Foodstuffs North Island Limited

**Resource consent for the
construction and operation of a new
supermarket with an associated drive
through fuel facility including car
parking and all other enabling works.**

SUPPLEMENTARY STATEMENT OF EVIDENCE (Transportation)

Alastair Black

Figure 1: Revised Intersection Layout¹ (Site Plan, 05/12/2018)

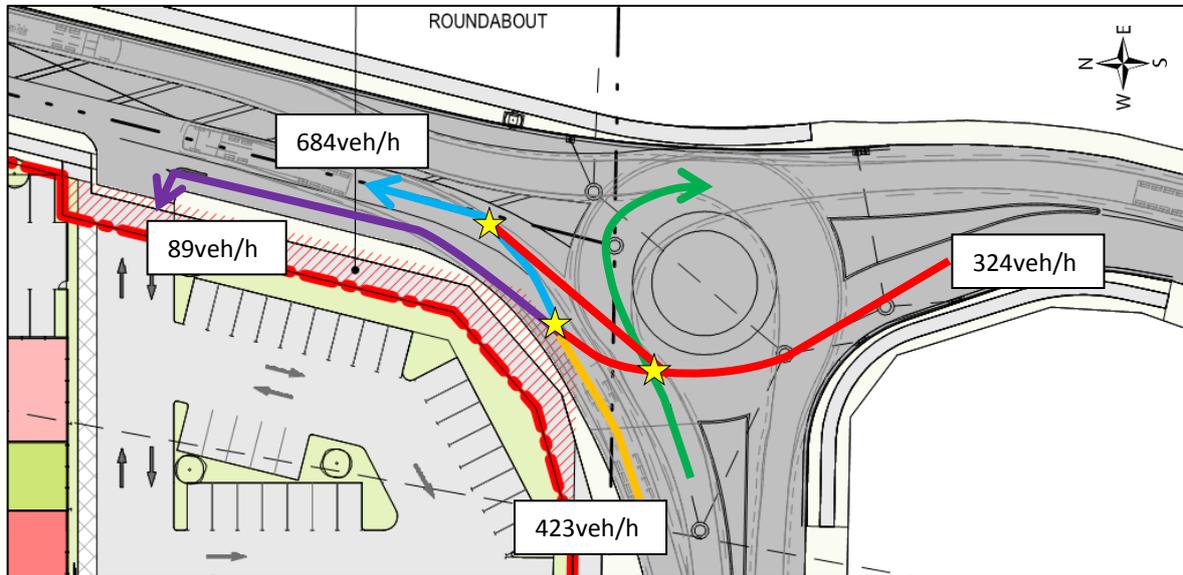
10. The introduction of the second departure lane and deceleration lane results in additional conflict points at the roundabout exit to Maui Street which I have shown as yellow stars on Figure 1. Figure 2 shows the traffic modelling outputs for the movements at the intersection.

11. As there are multiple departure lanes, I consider there is likely to be confusion on whether northbound vehicles are exiting the roundabout to continue north

12. It appears likely that all the traffic turning left from Eagle Way will be continuing north along Maui Street as they have already passed the site entry on Eagle Way. This increases the likelihood of conflict between these turning vehicles and those northbound from Karewa Place slowing to turn left into Pak'n Save.

13. The southbound approach to the roundabout is shown with a flush median. This creates the risk of two lanes forming on this approach which would result in serious safety effects as there is only one circulating lane. Austroads² states that *“The approach treatment (except for small roundabouts on local roads) should include a raised median (or splitter) island on the approach and a kerb along the left side of the approach which, in conjunction with the approach alignment, creates a physical restriction that slows drivers.”* As this is the intersection on a collector road (Karewa Place/ Maui St), I consider that this approach requires a raised splitter island.

17. The potential adverse effects could be mitigated by ensuring that detailed design of the roundabout complies with the relevant Austroads design standards. In my view this should include:
 - a. Removing or shortening the left-turn deceleration lane to reduce driver confusion on the exit from the roundabout and to avoid following vehicles be shadowed (refer paragraphs 35-41 below).
 - b. Providing a solid splitter island on the Maui St approach to the roundabout.
 - c. Maintaining access to the Couplands site.

Figure 3: Extract from Previous Layout (Site Plan, 05/12/2018)

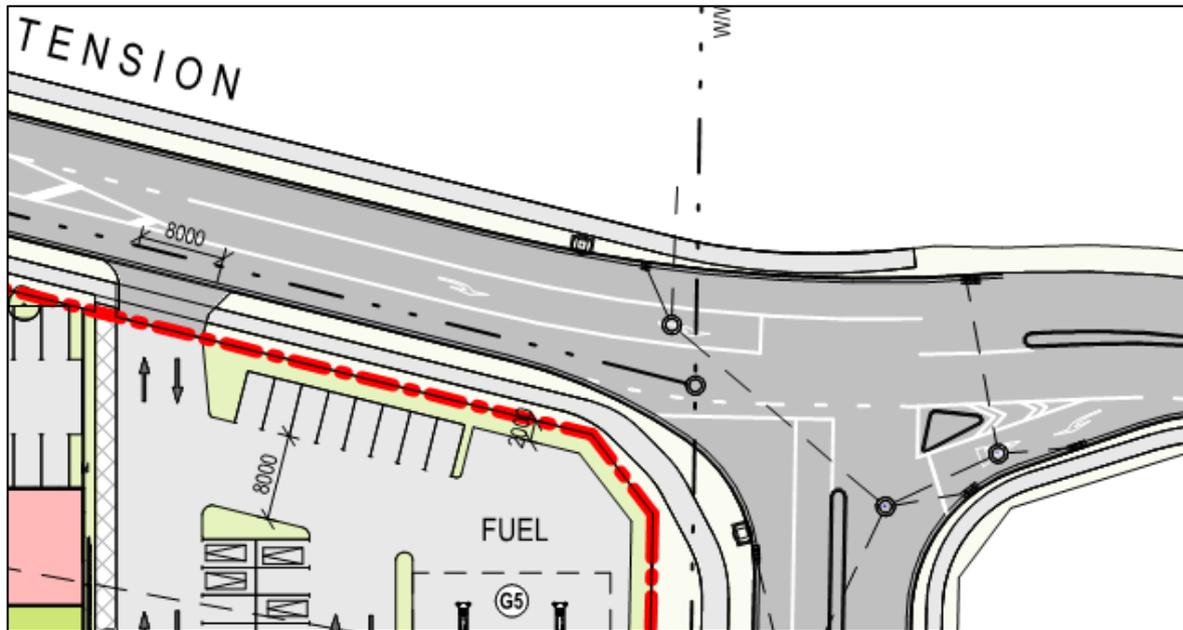
30. The 2031 VISSIM model outputs indicate 414veh/h will use the Maui Street access, equivalent to 7 movements/min. The average delays are 114s/veh (left-out) and 129s/veh (right-out).
31. The revised Maui Street access now includes a deceleration lane (refer Figure 1). The earlier site layout (refer Figure 3) was based a priority-controlled intersection that did not include a deceleration lane.

Figure 4: Revised Intersection Layout

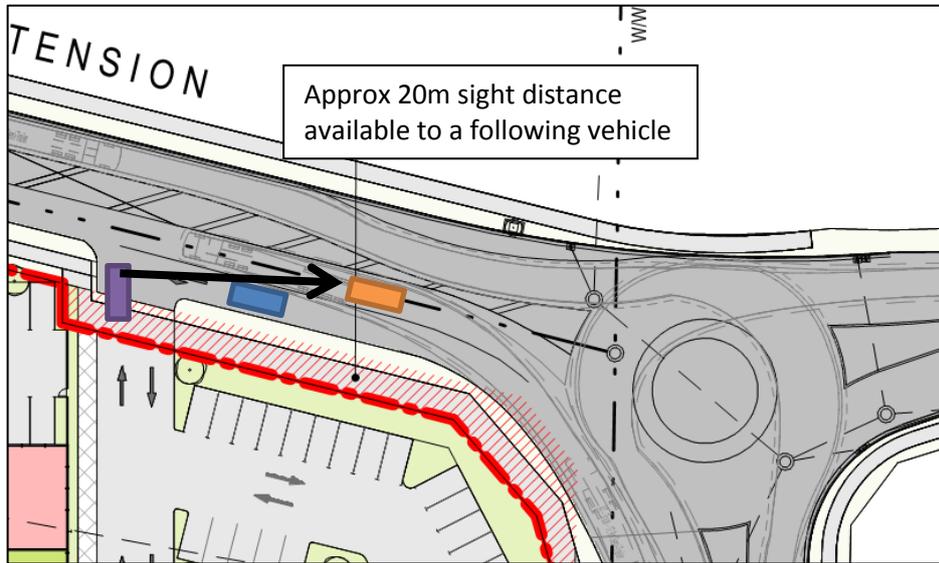
34. In my view, the most serious concern is the introduction of the deceleration lane which means that a vehicle turning left will obscure visibility to following vehicles as illustrated in Figure 4. A left-turning vehicle can reduce sight distance to approx 20m, the District Plan requires that 70m is provided at a vehicle crossing to a collector road with a 50km/h speed limit.

35. The risk of a crash from vehicles being obscured is significantly higher at this access when compared to the Eagle Way access as the traffic volumes are higher (161veh/h right-turning conflicting with 684veh/h northbound vehicles) and the Maui St access provides for all movements while the Eagle Way access is limited to left-in and left-out.
36. Without further mitigation, I consider that the proposed access to Maui Street is likely to have unacceptable adverse safety effects. I consider that the potential adverse effects could be mitigated by removing or shortening the left-turn deceleration lane to avoid shadowing of following vehicles.

37. Further information is required to assess the potential effects of the revised Te Rapa Road access on the neighbouring properties.
38. Without further mitigation, I consider that the proposed access arrangements are likely to have unacceptable adverse safety effects. If the proposal is approved, I consider that the further mitigation should include:
- a. Removal or shortening of the deceleration lane on Maui Street;
